2.4 Hydrologic Engineering

The Exelon Generation Company (EGC or the applicant) early site permit (ESP) site is located 6 miles (mi) east of Clinton, which is in DeWitt County in central Illinois, and is adjacent to the currently operating Clinton Power Station (CPS) Unit 1. Clinton Lake, an impoundment on Salt Creek, currently serves as the principal water source for the existing unit, which uses a once-through cooling system to dissipate heat from the turbine condenser. Water held behind a submerged dam constructed within the North Fork of Salt Creek in Clinton Lake provides the 30-day shutdown cooling water supply for the CPS Unit 1 ultimate heat sink (UHS). The applicant refers to this water source as the submerged UHS pond.

Figure 2.4-3 Proposed locations of ESP facility UHS intake and discharge

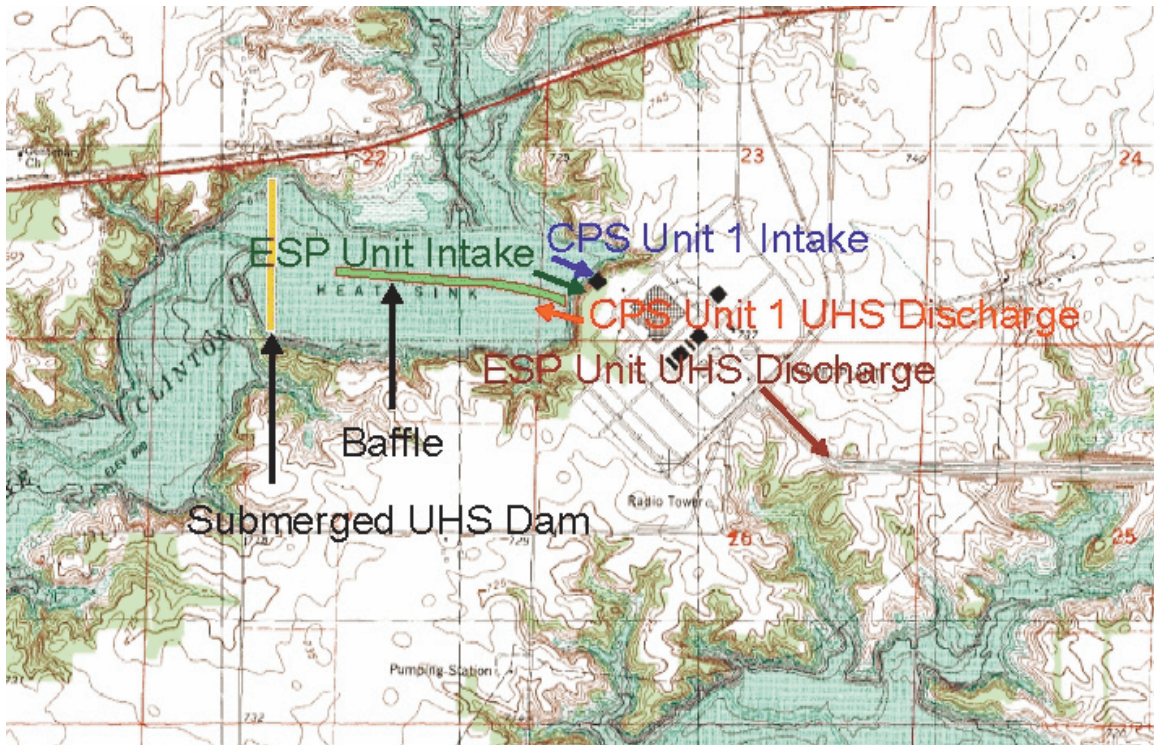
In Request for Additional Information (RAI) 2.4.1-1, the staff asked the applicant to provide survey coordinates (including elevations) for the bounding areas of all ESP facility safety-related structures, including intake tunnels and piping corridors. The staff also requested that the applicant provide coordinates of existing aquifers in bounding areas, particularly perched aquifers. In response to RAI 2.4.1-1, the applicant provided an updated figure to replace Figure 1.2-4 in Chapter 1 of the site safety analysis report (SSAR). The applicant stated that this figure shows the approximate location of safety-related structures, along with a grid system overlaid on the figure.

In RAI 2.4.1-1, the staff requested that the applicant provide additional information on survey coordinates (including elevations) for the bounding areas of all ESP facility safety-related structures, including intake tunnels and piping corridors. The staff requested that the applicant provide a layout of the intake tunnel and piping corridor from the lake to the ESP facility to determine the extent to which the COL applicant should address the layout as an interface item. The staff also asked for the locations of existing aquifers in the bounding areas, particularly perched aquifers. Although the applicant provided adequate information regarding the areal coordinates of the ESP site, it provided no information on the elevations required to define the bounding volume of the disturbed subsurface material. Therefore, the staff determined that the applicant needed to define the extent of the vertical disturbance and the bounding elevations of all SSCs. Additionally, the staff determined that SSAR Figure 1.2-4 did not identify either the elevations or the areal locations of the safety-related piping corridors. Since the intake pumps for the ESP facility UHS makeup water are safety-related structures, the staff determined that the applicant needed to state whether it covers these through the site grade specified in the PPE or proposes separate criteria for these structures. This was **Open Item 2.4-1** of the draft safety evaluation report (DSER).

The applicant indicated that the safety-related structures for the ESP facility are the intake structures, the essential service water cooling towers, and some other structures that will be located within the ESP facility powerblock area. The applicant stated that the final sizes and locations of the safety-related structures will be determined after the selection of a reactor during the combined license (COL) application and construction phase and that no survey coordinates are established at the ESP stage.

The applicant stated that the location of the ESP facility's normal and UHS intake structures is approximately 65 ft south of the existing CPS intake structures. The applicant selected this location to route the ESP facility piping without disturbing the CPS shutdown cooling water piping that runs from the CPS UHS. The CPS piping exits to the east of the intake structures. The CPS nonsafety service water discharge and fire protection discharge exit near the north end and then turn northeast. The circulating water discharge piping exits the intake structures south of the service water pipe as a group of three pipes that combine into a single pipe, which then turns northeast to the turbine building. The circulating water piping for the abandoned

In response to DSER Open Item 2.4-1, dated April 26, 2005, the applicant stated that the bounding foundation embedment is 140 ft below grade. The applicant also stated that the specific vertical disturbance and elevations of each SSC depend on the chosen reactor design and therefore have not yet been determined. The applicant explained that at 140 ft below grade, the foundation basemat will rest in Illinoian glacial till, which is considered very good foundation material. The applicant stated that any excavation below 140 ft from site grade will not be significant and will only be required for purposes such as leveling.

In response to RAI 2.4.1-1, the applicant stated that it expects the horizontal clearance between the existing CPS piping and the new ESP facility piping to be 50 ft. The staff determined that this proposed horizontal clearance is acceptable. The staff had planned to include this proposed horizontal clearance of 50 ft as DSER Permit Condition 2.4-1. The staff had also planned to include a minimum vertical clearance equal to the larger of 6.6 ft or three times the diameter of the pipes as DSER Permit Condition 2.4-2. However, based on a review of the applicant's response to DSER Open Item 2.4-1 above, the staff determined that DSER Permit Conditions 2.4-1 and 2.4-2 are not necessary because COL Action Item 2.4-1 is sufficient to ensure that the ESP facility intake piping will be installed with adequate clearance from the CPS facility piping.

Figure 2.4-4 The watershed draining into Clinton Lake, delineated manually using topographic contours

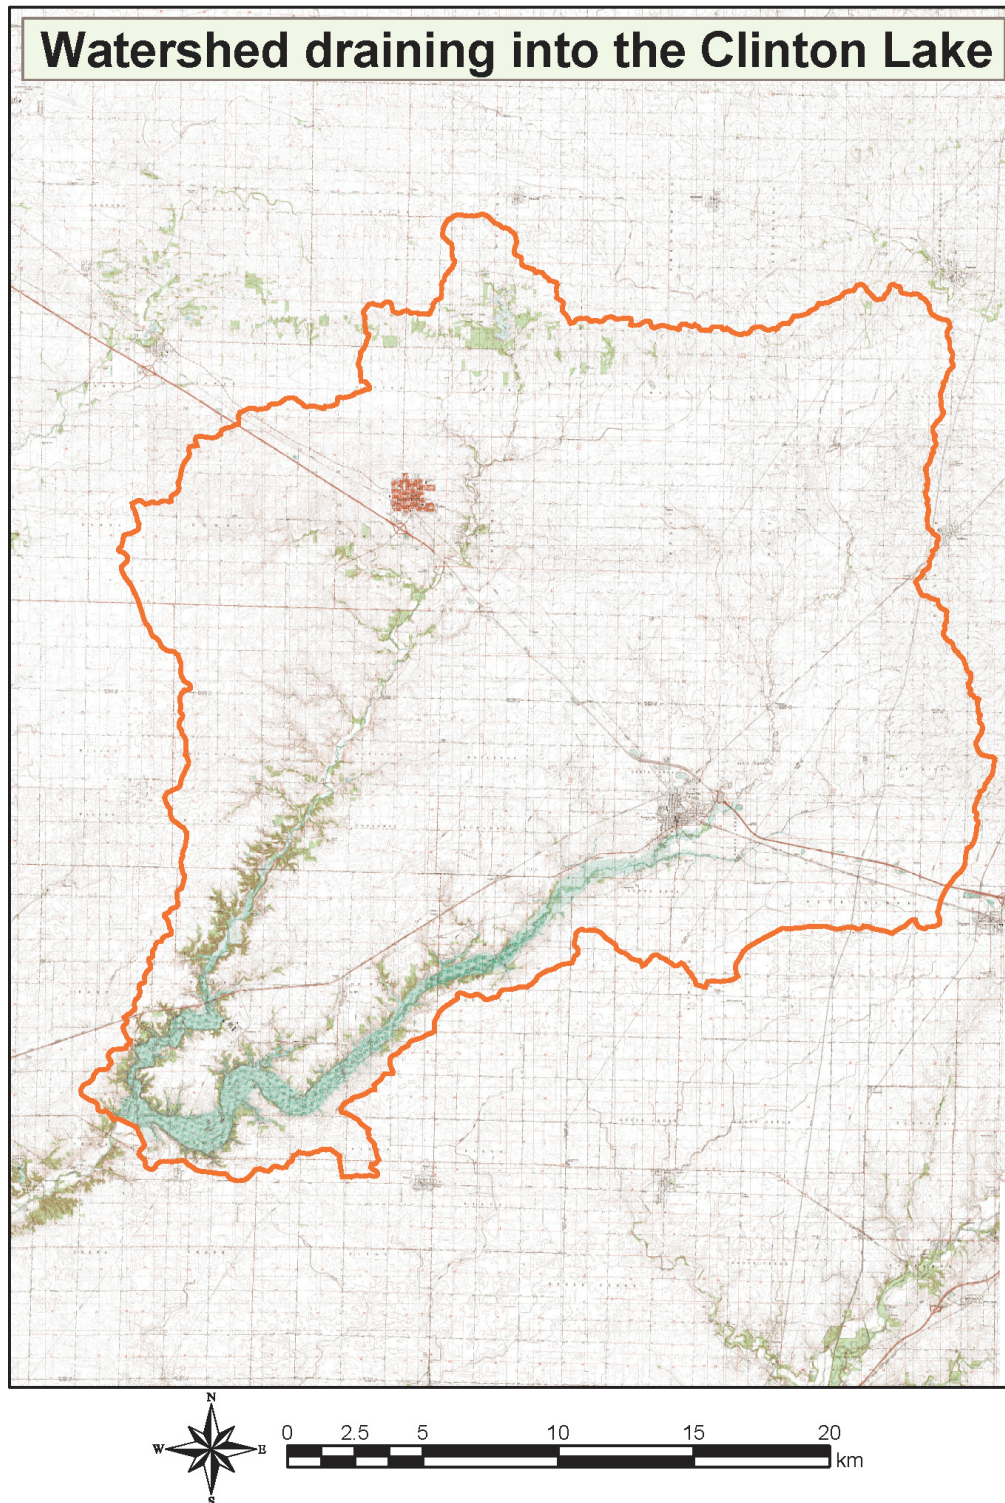
In SSAR Section 2.4.1.2, the applicant stated that the catchment area of Salt Creek above Clinton Dam is about 296 square miles (mi²). The staff manually delineated the watershed draining into Clinton Lake using USGS topographic maps (Figure 2.4-4 of this SER). The staff determined the area of the manually delineated watershed as 289.2 mi². The staff estimated the catchment area of Salt Creek above Clinton Dam to be approximately 2.4 percent less than that reported by the applicant.

Figure 2.4-10 Dawson Lake and Dam located approximately 17.1 miles north-northeast of the ESP site. Dawson Lake is located on the North Fork of Salt Creek.

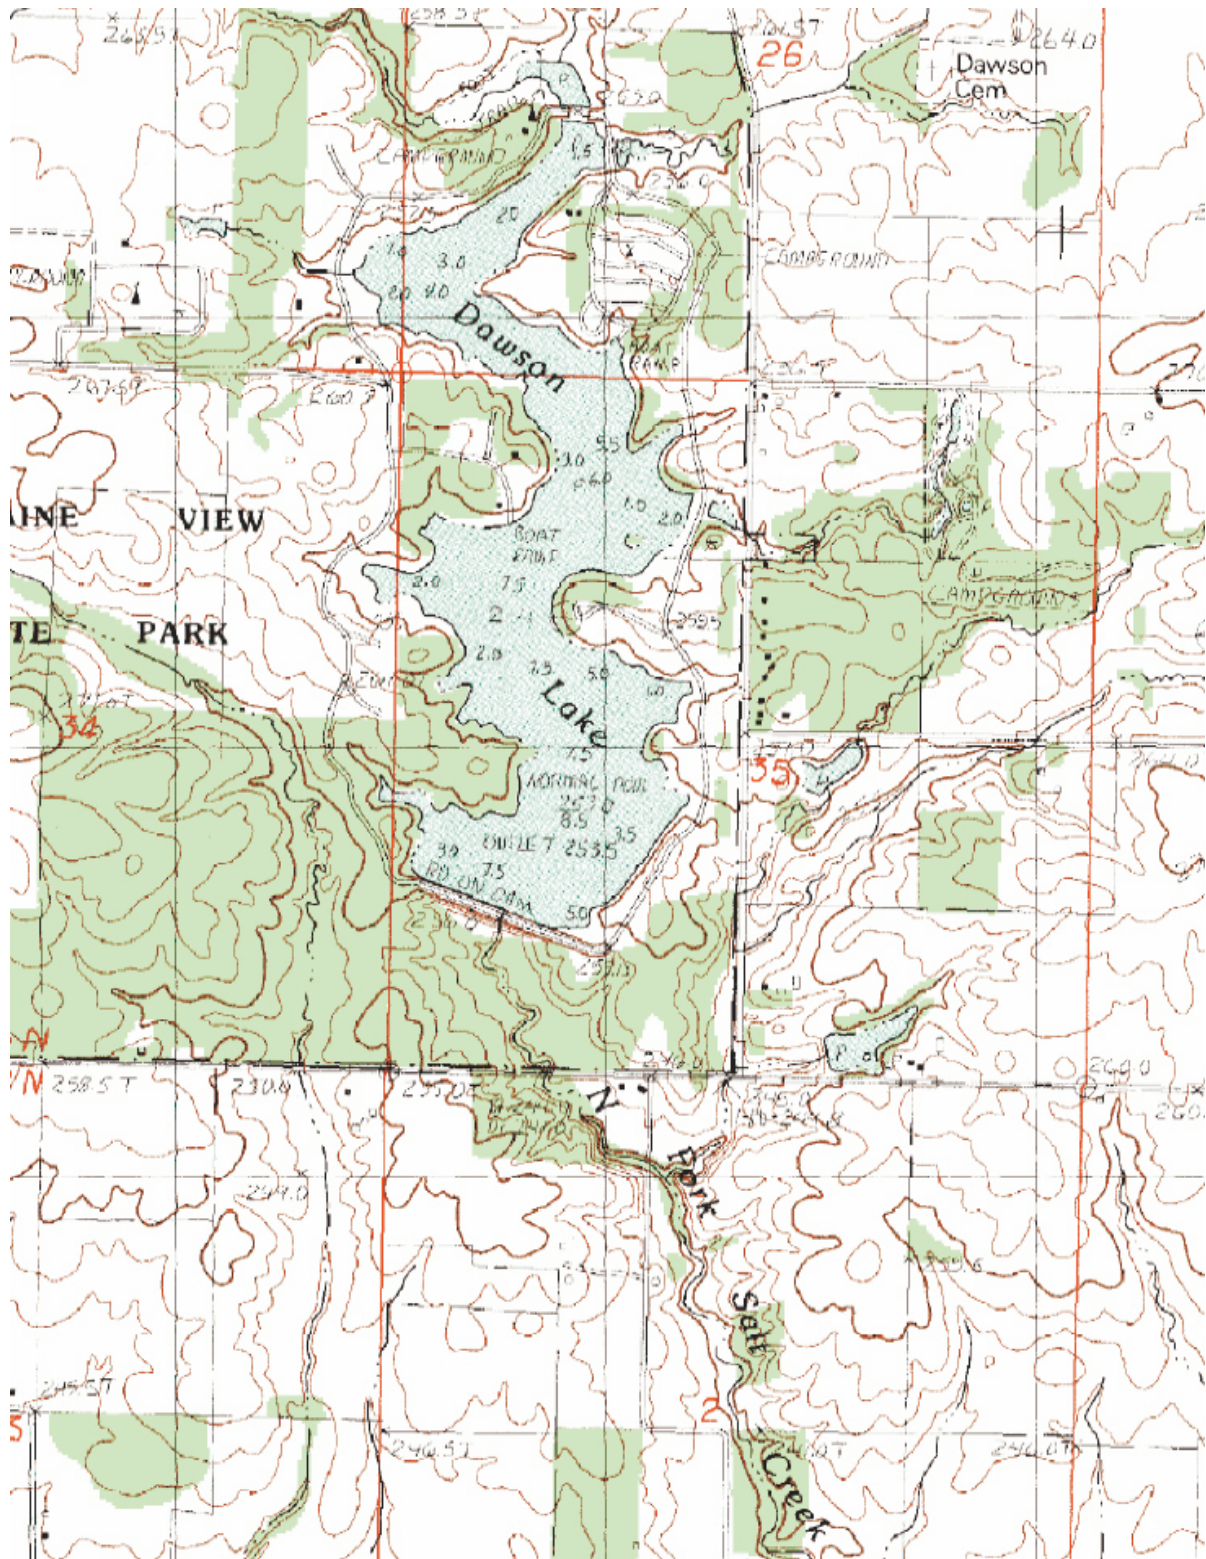
The staff determined that the maximum combined storage capacity of the two reservoirs upstream of Clinton Lake is 4446 ac-ft. The original capacity of Clinton Lake at normal water surface elevation of 690 ft MSL, as determined by the staff using the stage-storage relationship for Clinton Lake given in CPS USAR Figure 2.4-14, is 74,200 ac-ft. The maximum combined storage capacities of the two reservoirs upstream of Clinton Lake is about 6 percent of the normal storage capacity of Clinton Lake. The staff determined, using the same stage-storage relationship for Clinton Lake, that an increase in storage by 4446 ac-ft, with an initial water surface elevation in Clinton Lake of 690 ft MSL, would result in an increase in water surface elevation of 3.1 ft. This estimate is very conservative, since it ignores water discharged over the service spillway when the water surface elevation in Clinton Lake exceeds its crest elevation of 690 ft MSL. Discharge over the service spillway reduces the water surface elevation in Clinton Lake, and the final increase in water surface elevation resulting from a breach of the two upstream dams is likely to be less than 3.1 ft.

The staff's estimate of maximum water surface elevation in Clinton Lake because of PMF, wind setup, and wave runoff, as discussed in Section 2.4.3 of this SER, is 721.7 ft MSL. The staff plans to include 721.7 ft MSL as a site characteristic in any ESP that might be issued for this application. Even if the maximum water surface elevation in Clinton Lake were to be augmented by 3.1 ft because of a breach of the two upstream dams, leading to a water surface elevation of 724.8 ft MSL in Clinton Lake, the ESP site, located at 735 ft MSL, would be safe from flooding. Therefore, the staff determined that the applicant's response to RAI 2.4.1-3 is satisfactory.

Figure 2.4-11 Clinton Power Station site and fetch length

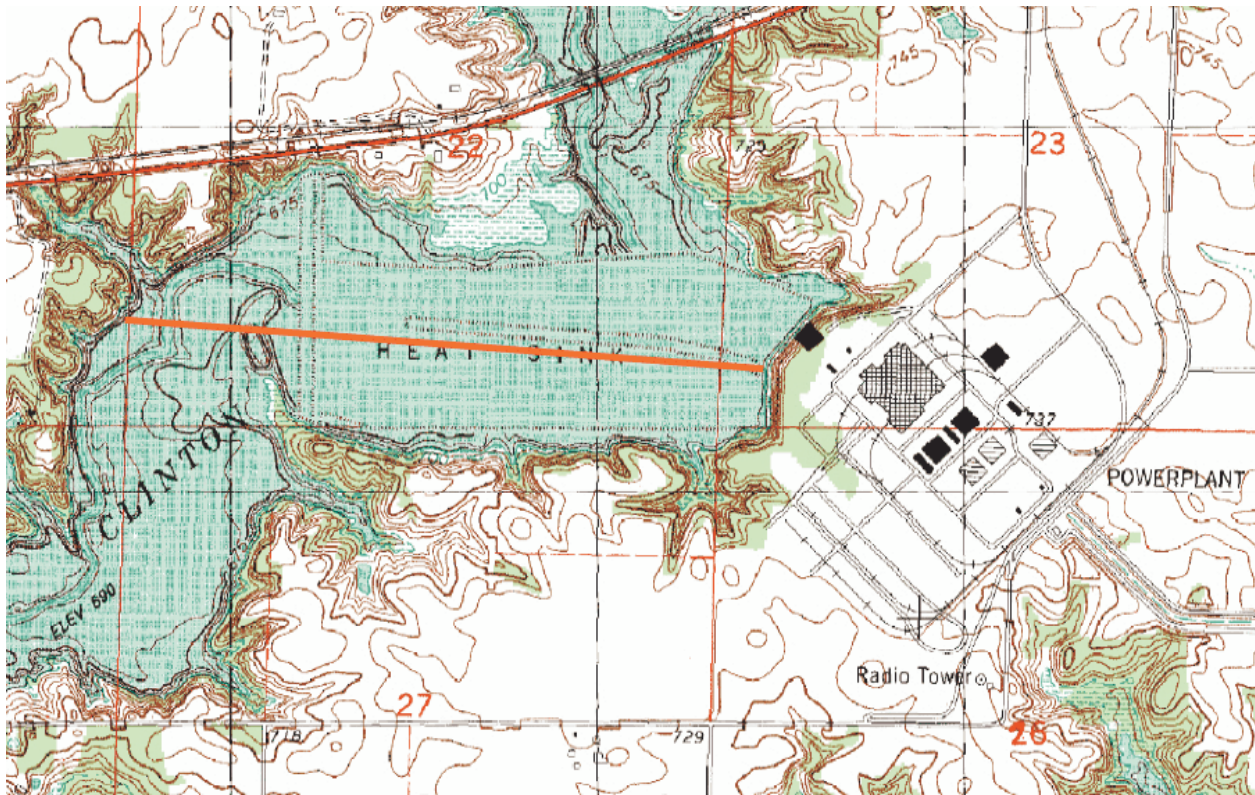
The following describes the staff's independent evaluation performed to estimate seiche effects. Fetch length is one of the key parameters for determining wind setup and is generally based upon the longest straight-line distance from the site to the opposing shore. Although the site is approximately 3 miles from the dam and 10 miles from the upstream end of the reservoir, the longest straight-line distance to the opposing shore is approximately 6340 ft (see Figure 2.4-11 of this SER).

The staff estimated the period of oscillation resulting from seiche, along the fetch length line shown in Figure 2.4-11 of this SER, based on the theory for free oscillation of water of uniform depth and temperature in a rectangular basin (Wilson, 1972):

Figure 2.4-14 AFDD during 1977-78 as calculated by Engineering Research and Development Center, Hanover, New Hampshire.

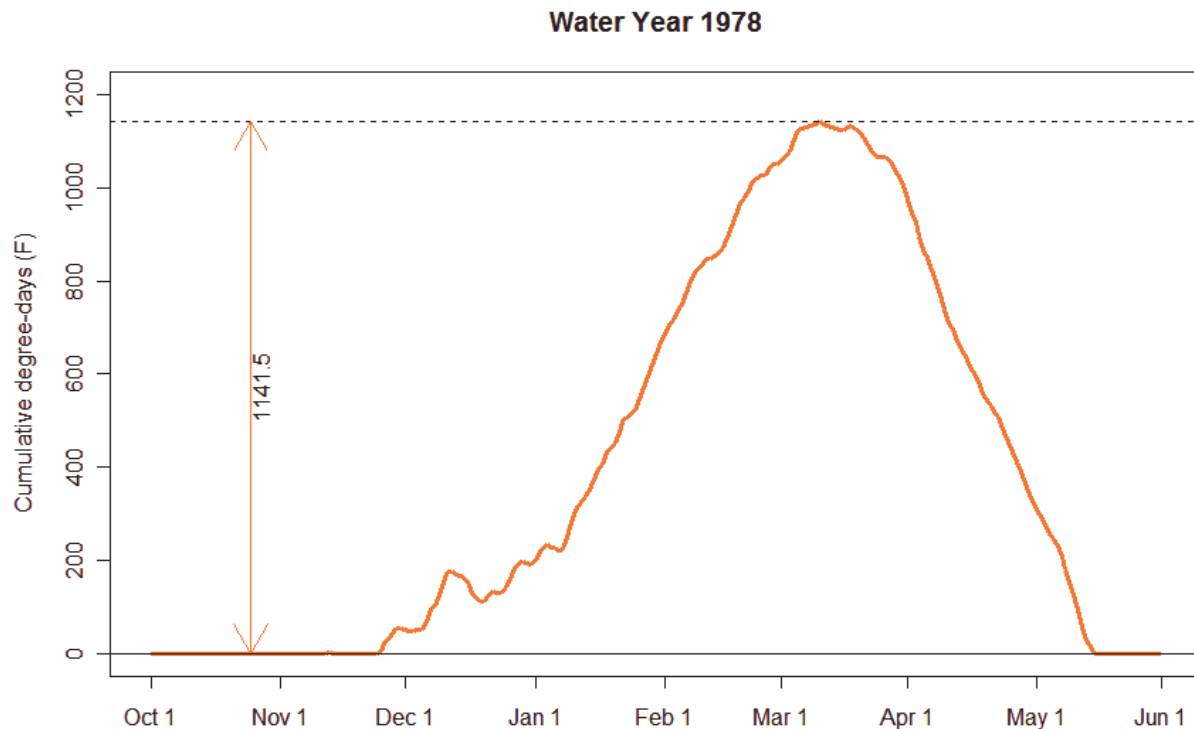
years on record varied from November 16 to March 5, with 14 percent falling in November, 60 percent in December, 21 percent in January, four percent in February, and one percent in March. Fifteen percent of “zero AFDD” dates preceded December 1. The staff determined that winter of water year 1978 (calendar years 1977-1978) was the coldest on record with a maximum AFDD of 1141.5 EF (Figure 2.4-14 below). The “zero AFDD” day for this year was November 25, 1977. The maximum AFDD occurred on March 10, 1978. The staff revised their estimate of maximum ice thickness in Clinton Lake to 27.0 in as shown below.

$$h_i = \alpha \cdot \sqrt{AFDD} = 0.8 \times \sqrt{1141.5} = 27.0 \text{ in}$$

The applicant revised its ice thickness estimation and described the revisions to the application in a letter dated December 21, 2005, to the NRC. The applicant stated that ice thickness was estimated for the Clinton Lake during the period 1902-2001. The applicant obtained AFDD data for Decatur, Illinois, from the ERDC and revised its estimation of ice thickness using the procedure described in the USACE Engineering and Design-Ice Engineering Manual (EM1110-2-1612) and USACE technical note ERDC/CRREL TN-04-3. The applicant used a value of 0.8 for the coefficient of ice cover condition (α in the equation above). The applicant reported that the mean ice thickness estimated over the period 1902-2001 is 16.2 in. with a maximum ice thickness of 27.0 in. during the 1977-78 winter.
